**NEW YORK STATE THRUWAY AUTHORITY
DEPARTMENT OF ENGINEERING**

**AMENDMENT NO. 2
TO**

**CONTRACT TAN 26-14
D215082
PAVEMENT REHABILITATION AND MISCELLANEOUS
WORK ON I-190, NIAGARA THRUWAY
FROM MP N0.7 TO MP N4.2
IN THE BUFFALO DIVISION
OF THE NEW YORK STATE THRUWAY
IN ERIE COUNTY**

**IN THE LETTING OF
FEBRUARY 25, 2026**

TITLE OF PROJECT I-190 HIGHWAY REHABILITATION	CONTRACT NUMBER: TAN 26-14
LOCATION OF PROJECT I-190 NIAGARA THRUWAY MP 900.7 TO MP 904.2	DATE: FEB. 2026
TITLE OF DRAWING ROADWAY PLANS	DRAWING NUMBER: PL-32

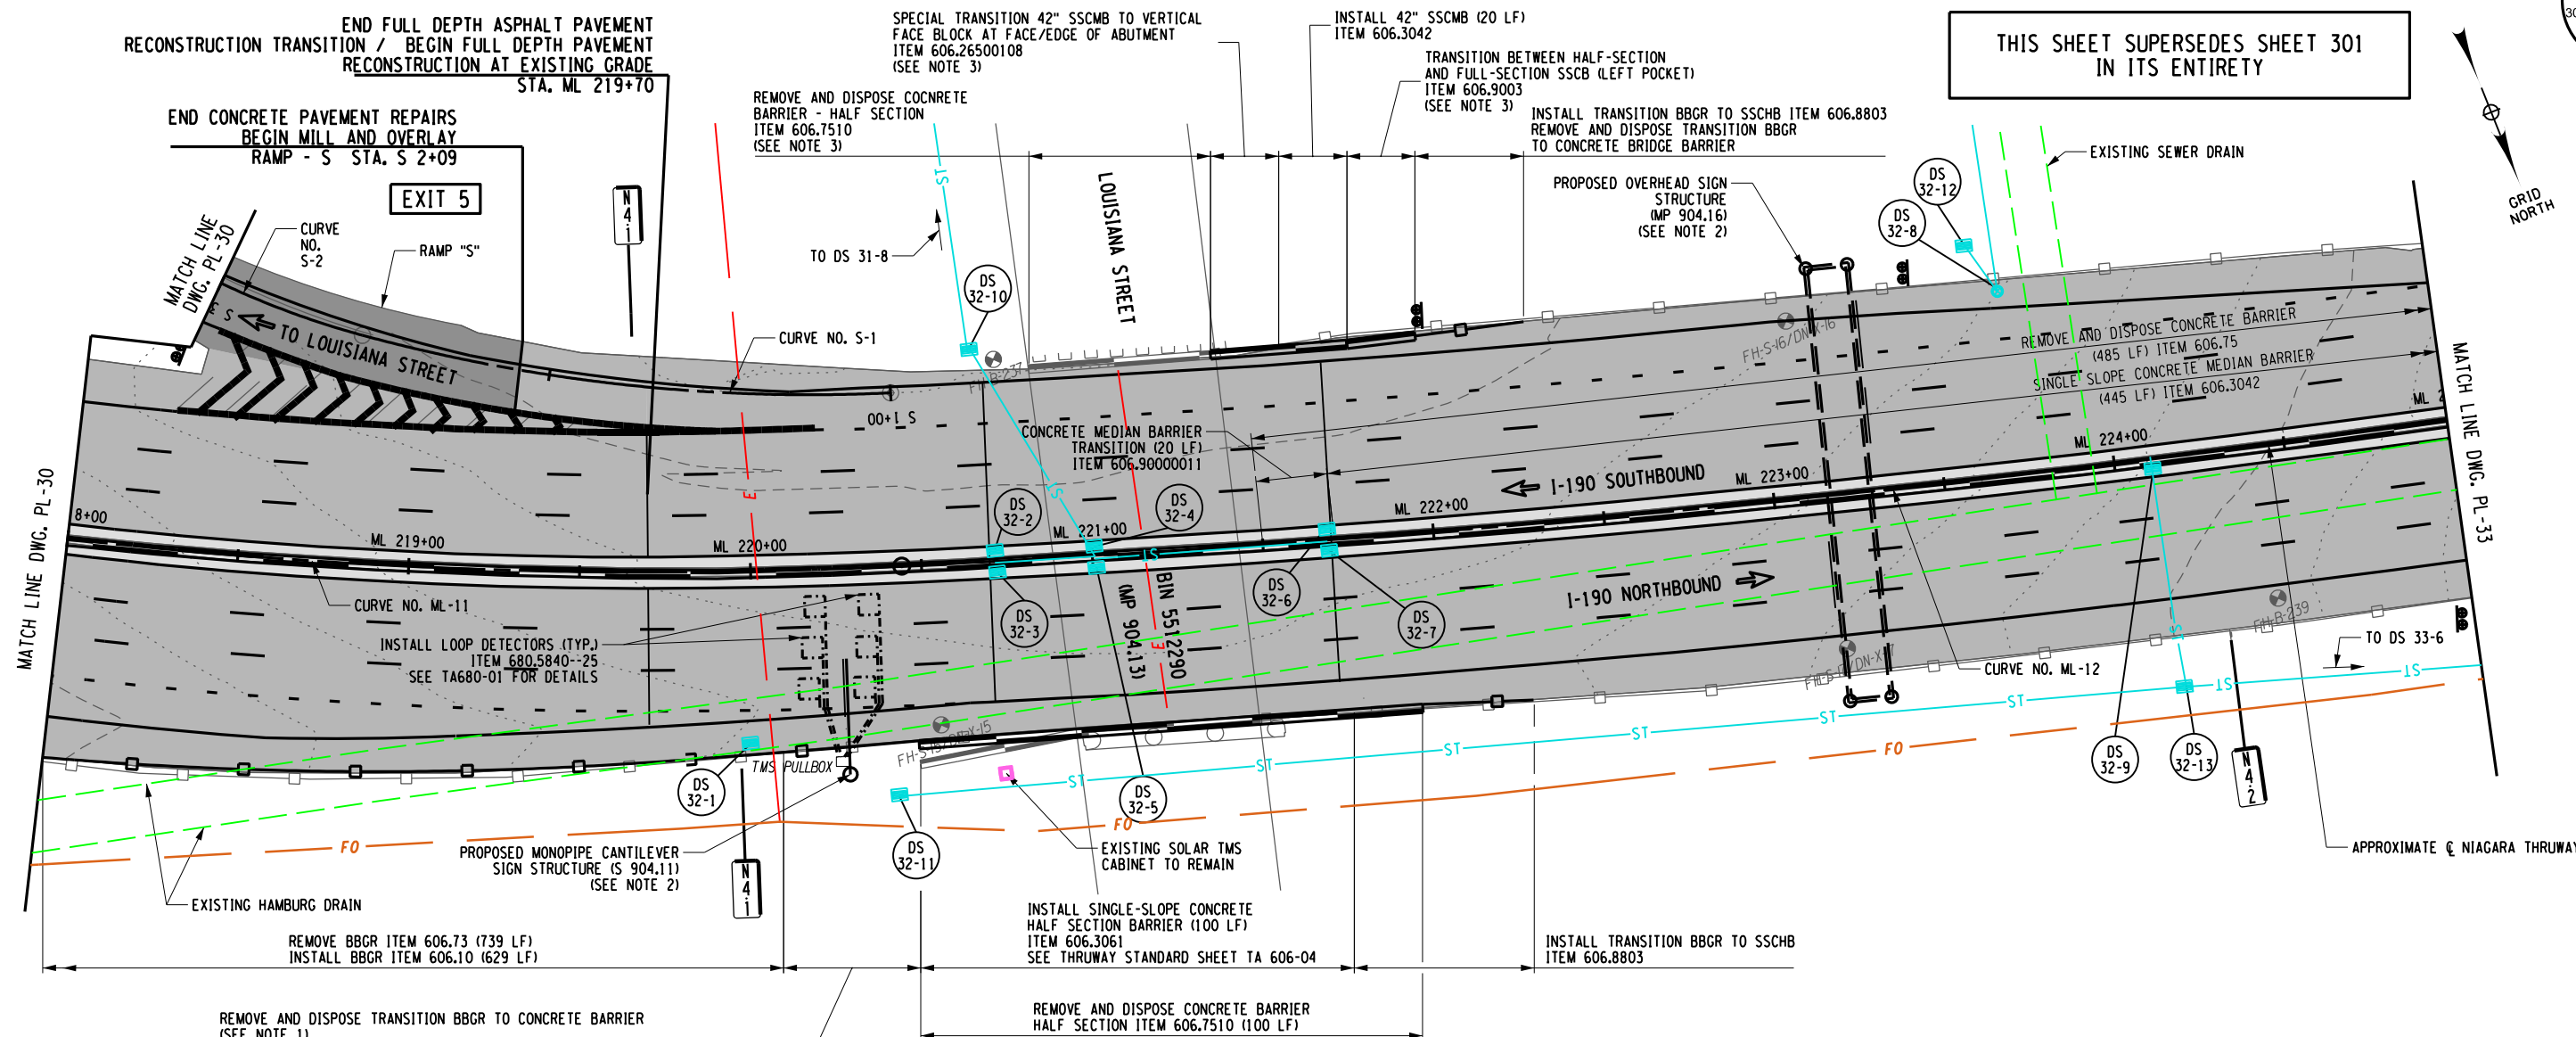
22. **DELETE** Drawing Number PL-32, Sheet 301 of 421, and **SUBSTITUTE** with the attached Drawing Number PL-32, Sheet 301-A2 of 421. The limits to remove and dispose of existing concrete barrier and replace with single slope concrete median barrier has been revised and now extend to Station ML 221+50.
